**OPTIMUS 50 kW generator**
**PCB kV control EZ130 modification instruction**
**for all PCB's 4512 108 05843/4/5** for Optimus 50kW
and 4512 108 08661--4 for 65/80kW

CPL
OFS
MTB
DLY -1
SMP 512
DAT 26/07/95
TIM 14:33:26
ATN
CPL
OFS
MTB
DLY
SMP
DAT
TIM
(1)

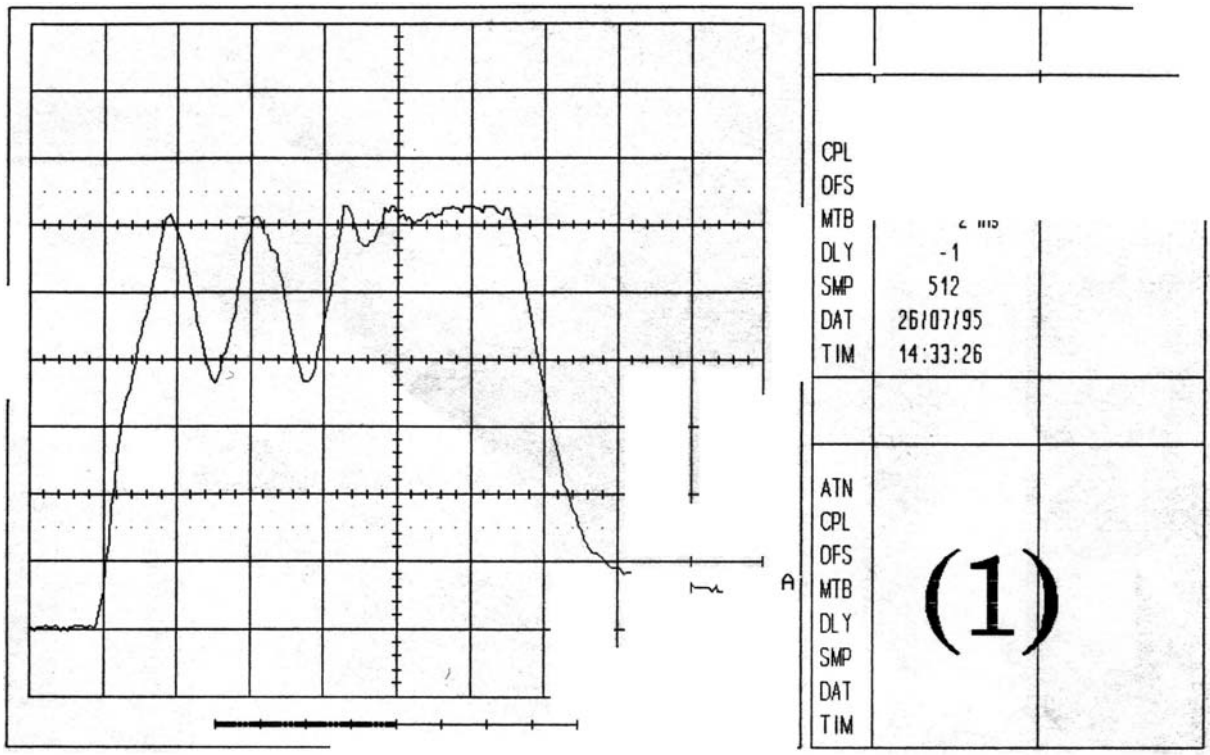
The kV waveform, measured at EZ130 X3 (total kV) against EZ130 X6 (ground), might look like the attached scope pictures (1) and (2) in any kV stage.
Scope settings:
- 1V/div (20kV/V)
- 2ms/div
- trigger with positive slope (kV rise) or external trigger CTRL_X_C/ EZX74 negative slope (backpanel measuring point).

If the errors are coming up and/or the kV waveform is similar to the scope pictures (1) and/or (2) then solder an additional resistor parallel to resistor R226 on PCB EZ130 kV_control.
X The value is 475kΩ ⅛W (12NC 2322 156 14754), the position on the PCB is given on the layout drawing.

max 10kV
A
ATN 1 V
CPL DC
OFS -4.04 V
MTB 2 ms
DLY -1
SMP 512
DAT 26/07/95
TIM 14:34:38
ATN
CPL
OFS
MTB
DLY
SMP
DAT
TIM
(3)
X6
X5
X4
X3
X10
A201
A200
R212
R211
V202
X32
N*
X24
R226
R225
R224
C210

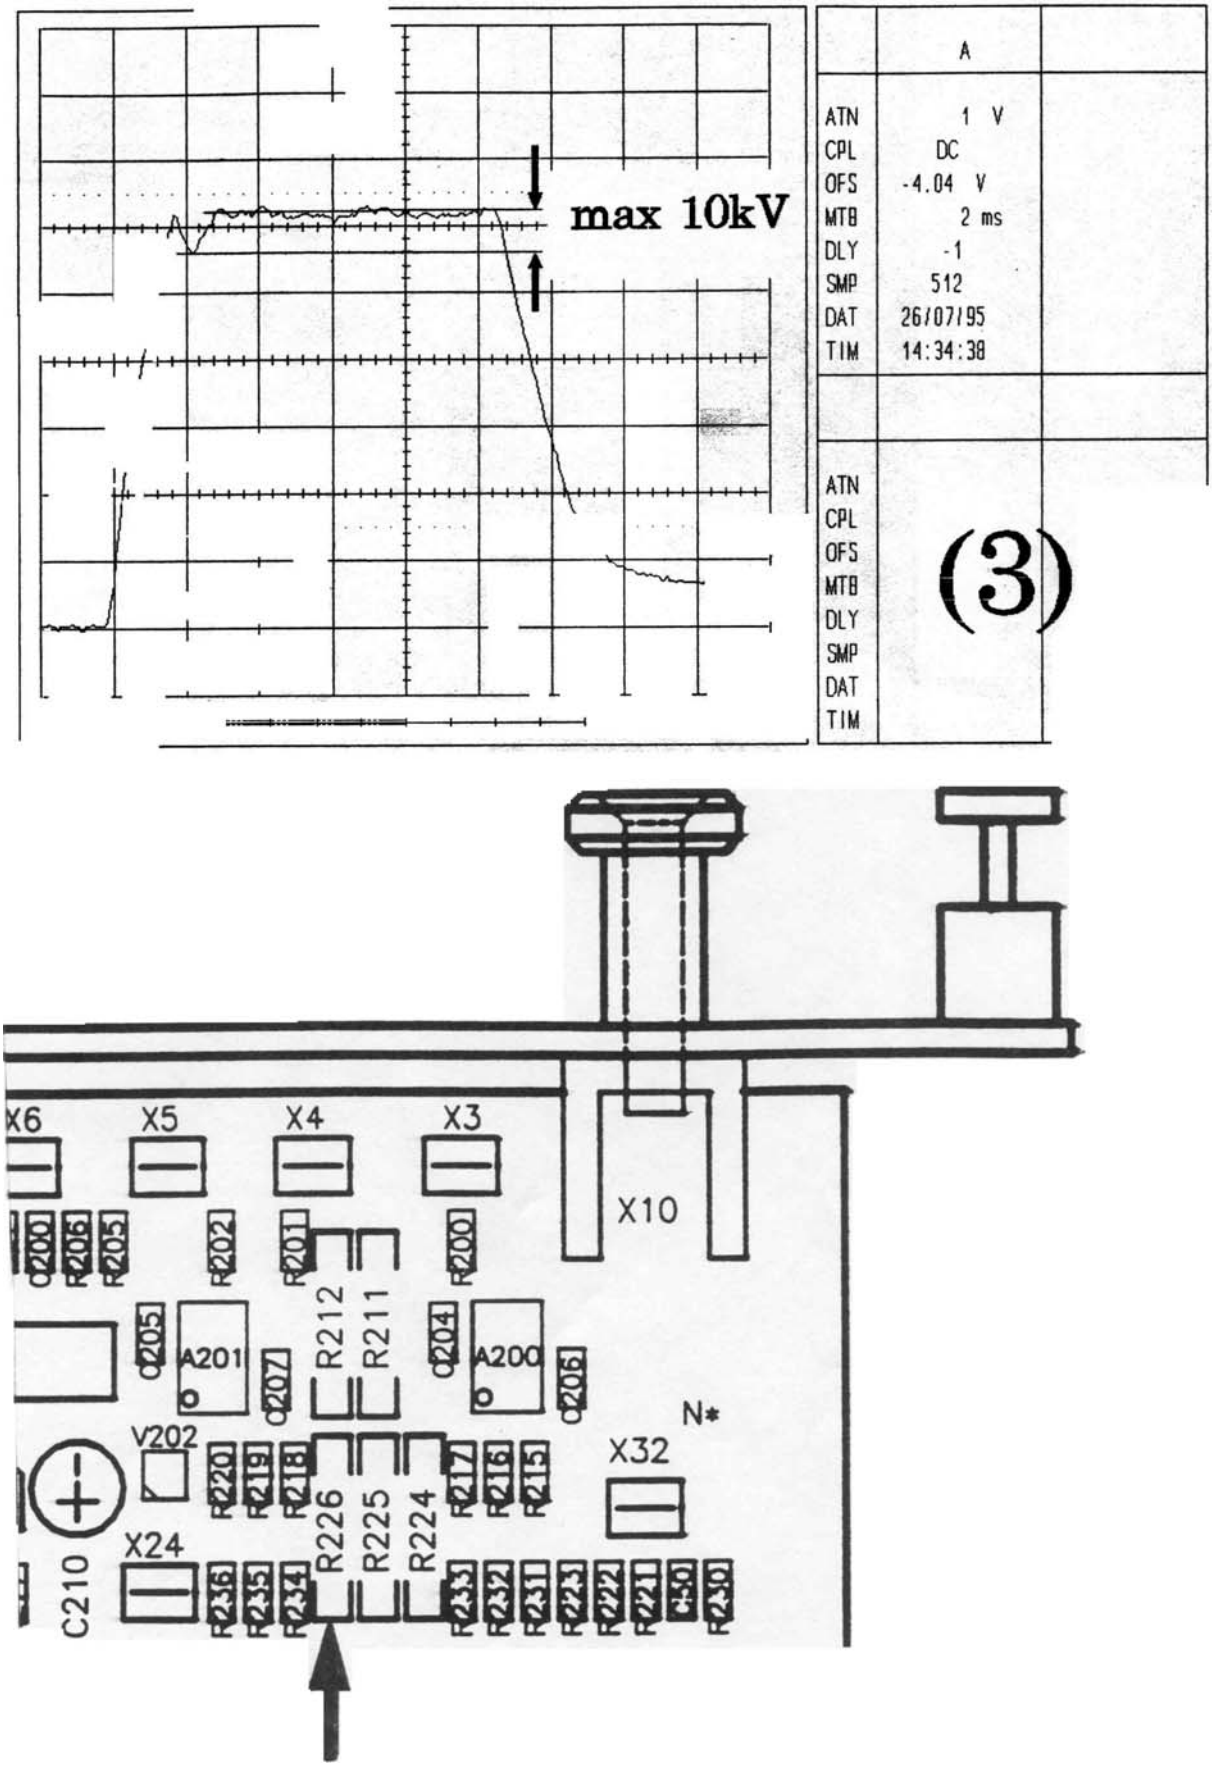
The 'swing' of regulation should not increase 10kV (see scope picture (3)).

X Also possible: 392kΩ
475kΩ
562kΩ
681kΩ
825kΩ
1MΩ
